Application reference: 12/0590/FUL HAMPTON WICK WARD

19 - 21 Melbourne Road, Teddington, ,

Erection of two new houses

Flood Map for 19-21 Melbourne Road, Teddington

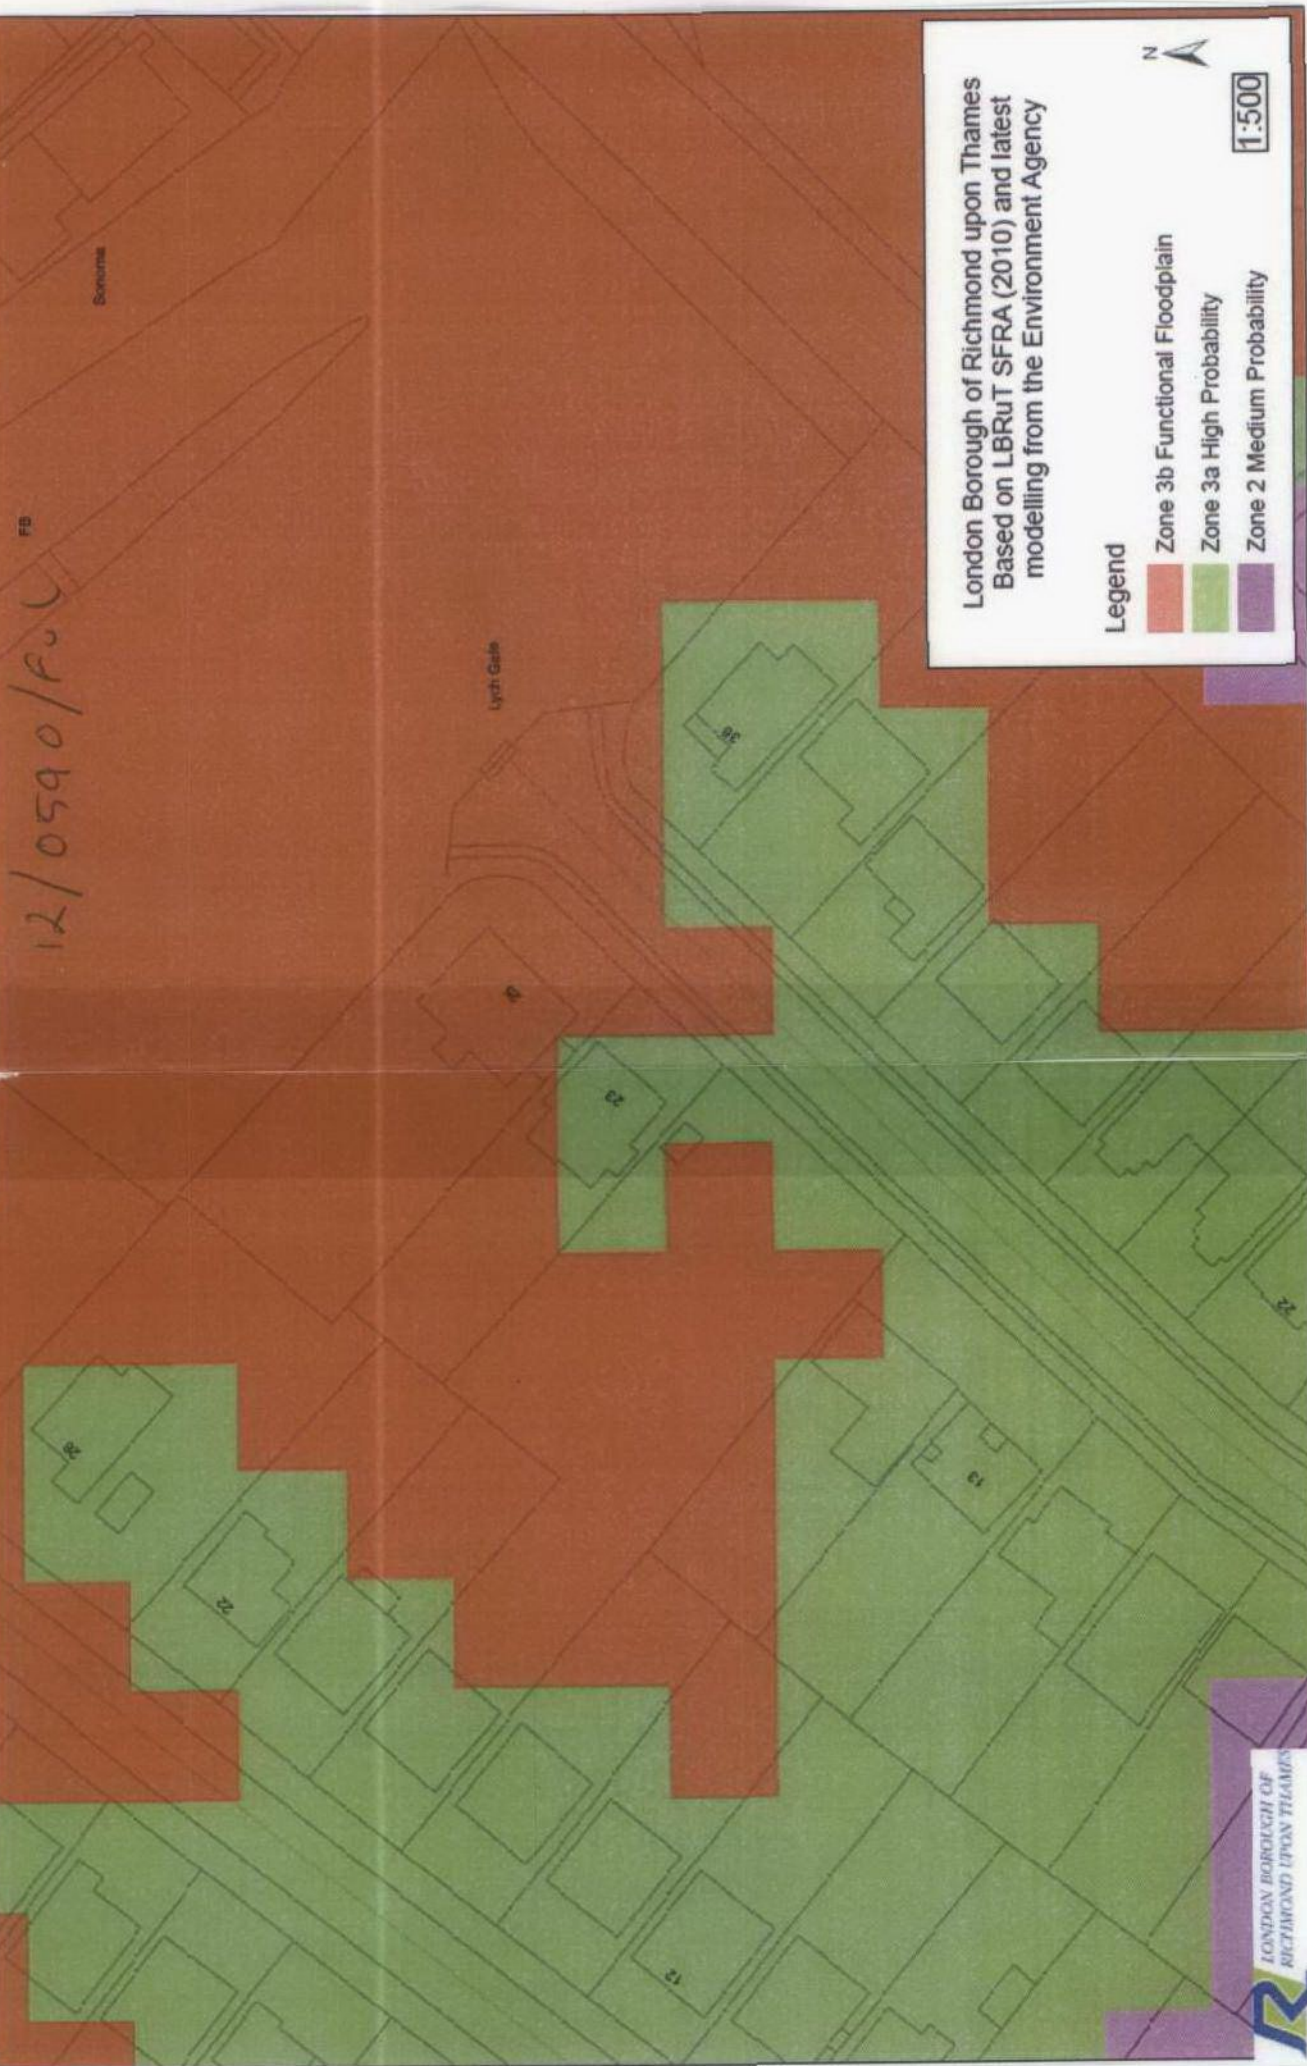
That part of the site is below the EA modelled 1 in 20 annual probability flood level is reflected in the Council's updated SFRA map, incorporating the same EA modelling data (February 2011). However, it is clear from the updated map that the majority of the site is subject to flooding up to and including the 5%, most notably the area where the proposed houses would be sited. As such, it is considered that the designation as a functional floodplain (Flood Zone 3b) and the objection in principle is justified and warranted. A copy of the map showing the relevant site is attached to this report.

The application site lies within Flood Zone 3b (functional floodplain) and the proposal fails the PPS 25 and NPPF Sequential Test as residential development is considered to be 'more vulnerable' in terms of flood risk vulnerability and is not permitted in Zone 3b. By reason of their siting, form, design and landscaping the proposed houses would fail to relate satisfactorily to the prevailing character and would appear incongruous in the streetscene. Furthermore, by reason of their height, siting and boundary treatment, the raised decking would result in an unacceptable level of overlooking and loss of privacy into neighbouring gardens. Therefore, the proposal is considered contrary to the aims and objectives of National and Council policy.
